ATTACHMENT 2A TO AEP:NRC:0433Q

TECHNICAL SPECIFICATIONS PAGES MARKED TO SHOW PROPOSED CHANGES

UNIT 1

The Licensee proposes to make administrative changes to several technical specifications (T/S) for Donald C. Cook Nuclear Plant unit 1 and unit 2. The proposed changes include: (1) revising boron sampling requirements in mode 6; (2) deleting a reference to obsolete equipment in a footnote; (3) deleting a redundant figure; (4) correcting a reference to another requirement; (5) deleting obsolete notes; (6) adding to surveillance requirements; (7) clarifying instrumentation configuration; and (8) correcting typographical errors. These changes are proposed to remove obsolete information, provide consistency between unit 1 and unit 2, provide consistency with the Standard Technical Specifications, provide clarification, and correct typographical errors.

Figure 5.6-3: Acceptable-Burnup-Domain in Regions 2 & 3

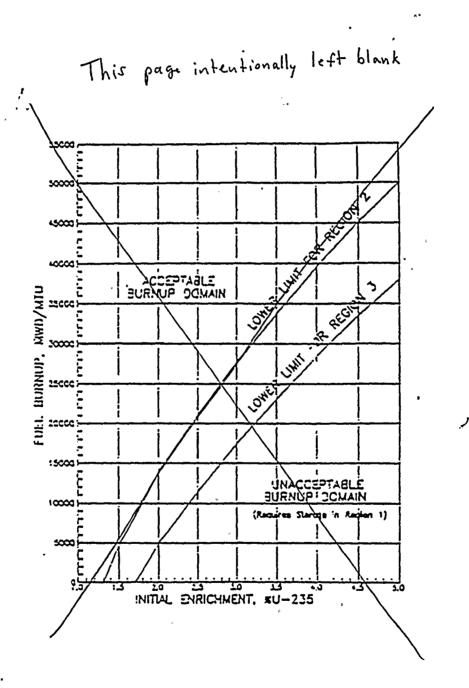
The equivalent reactivity criteria for Region 2 and Region 3 is defined via the following equations: __and_graphically_depicted-in-Figure 5.6-3.

Figure 5.6-3 intentionally deleted.

Deleting the redundant figure for equivalent reactivity criteria for regions in the spent fuel storage racks does not impact the storage requirements because the equations provide equivalent requirements. The unlikely event of a fuel assembly being misloaded is independent of the characteristics of the spent fuel in the pool. It has no impact on the event initiator, which is a human error while positioning a fuel assembly. The change has no impact the assumptions for a fuel handling accident because the fuel storage requirements are not changed. The consequences of an accident are not increased because the fuel storage requirements are not changed and no other changes are made to systems that mitigate the consequences of an accident.

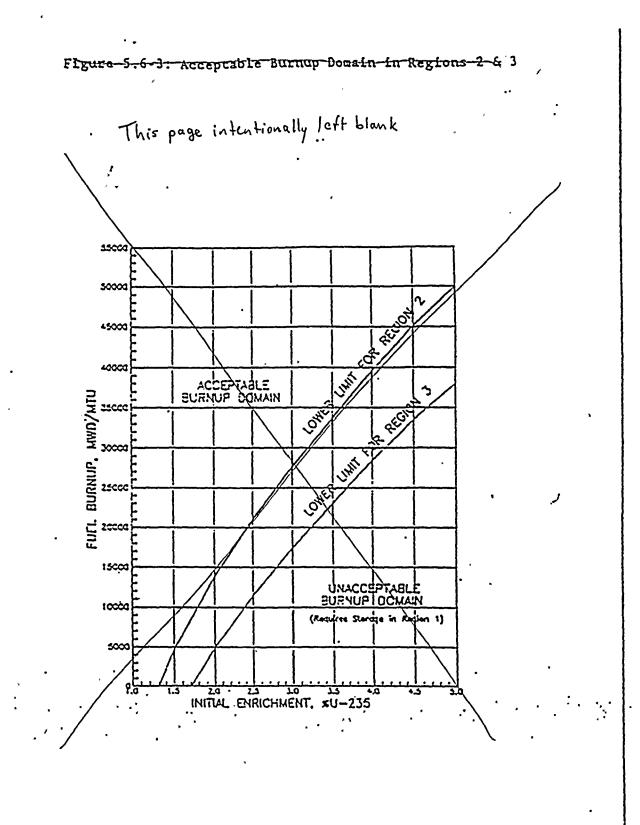
The equivalent reactivity criteria for Region 2 and Region 3 is defined via the following equations and graphically depicted in Figure 5.6-3:-

Figure 5.6-3 intentionally deleted.
